TITLE OF PROJECT: Fee Hall – Upgrades to C-Wing

PROJECT NUMBER: CP24035

ADDENDUM NO: 1

FLOOR PLAN
SCALE: 1/4" = 1'-0"

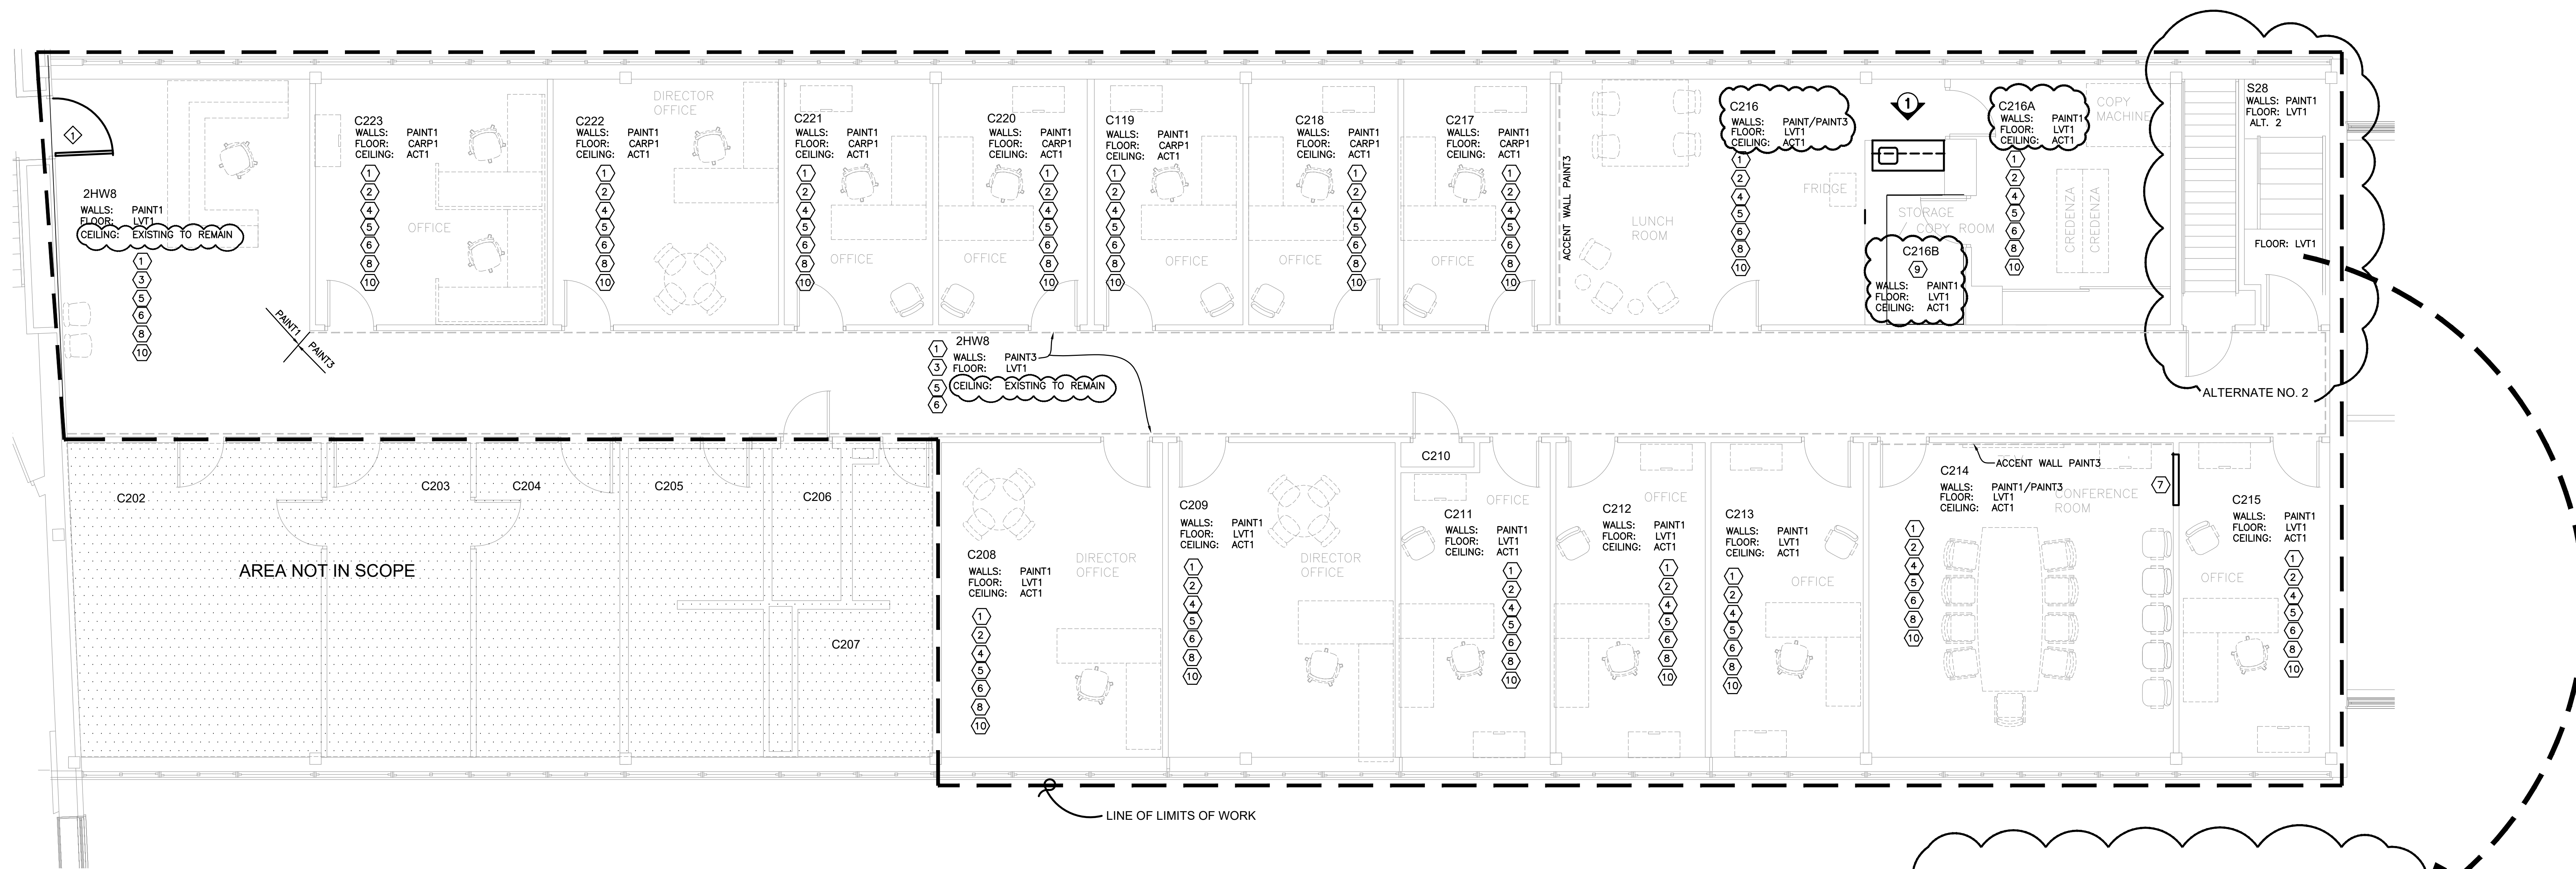
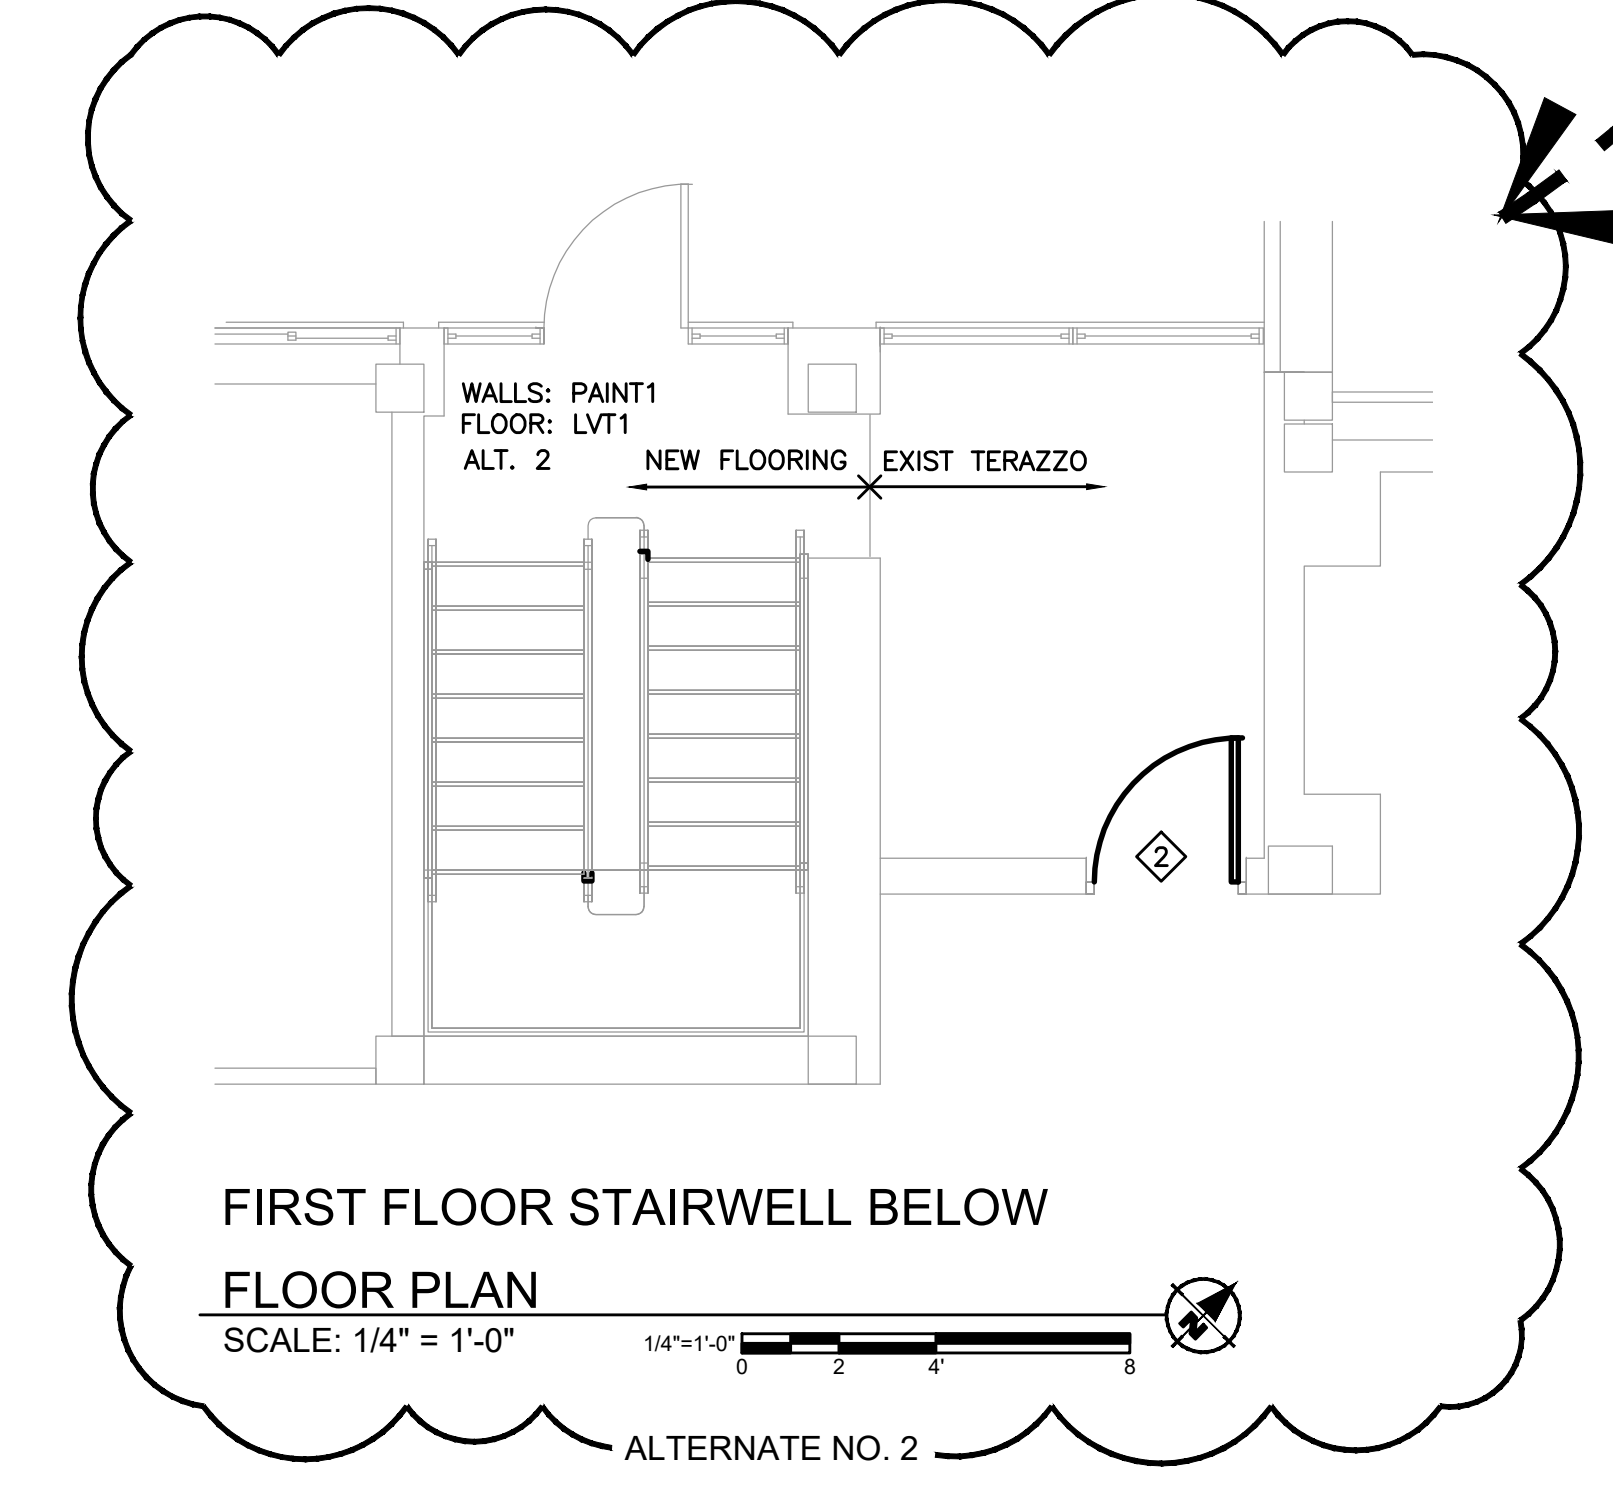
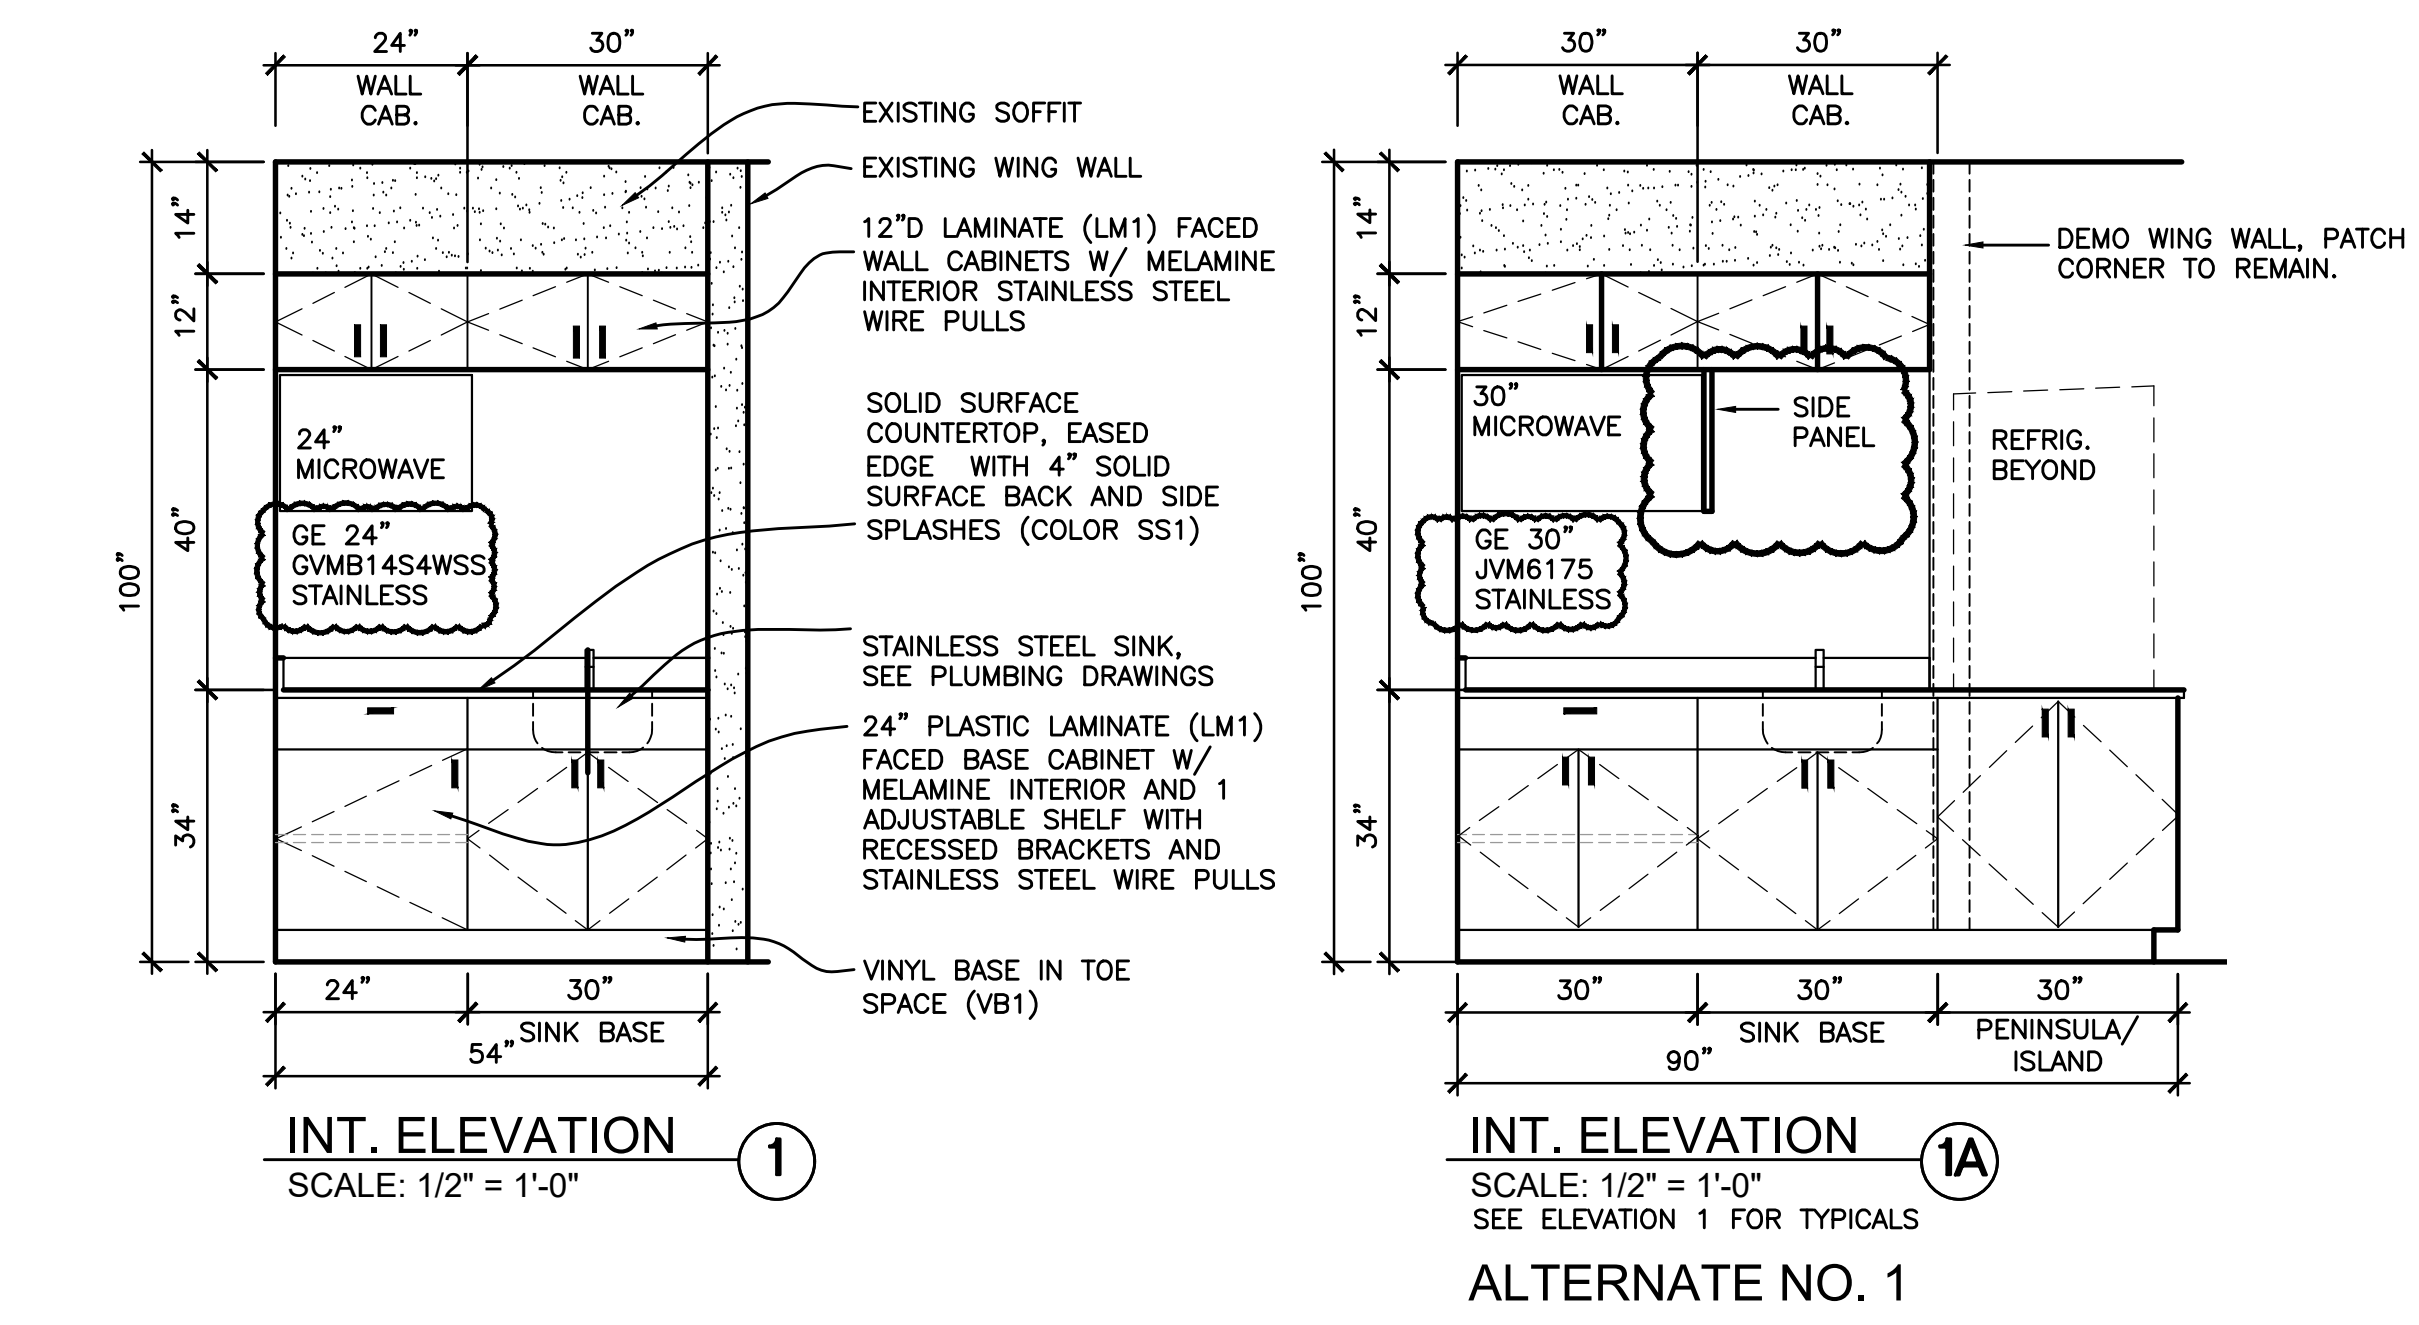
12	Reuse existing hollow metal door frame for add alternate 2
13	For add alternate #2 - No LVT on treads. New LVT on landings only, existing vinyl

- treads on steps to remain
- 14 Door frames are painted color PT2.
 - 15 Feature walls at 2HW8, C214 and C216 Painted PT3.
 - 16 Flooring Correction Rooms C216,C216A C216B should be LVT1 not Carpet.
 - 17 Stairwell landings to Be LVT1 not LVT2 there is to be no LVT2.
 - 18 (we may want to remind the client that this was the given direction as it may appear to be a half measure and not an impactful upgrade, LVT1 is a wood grain LVT. Given the pictures below and what remains.....)
 - 19 Alternate 1 now includes removal of closet and associated patching.
 - 20 Corridor ceiling tile correction called out as existing in lieu of ACT1
 - 21 Microwave models called out.
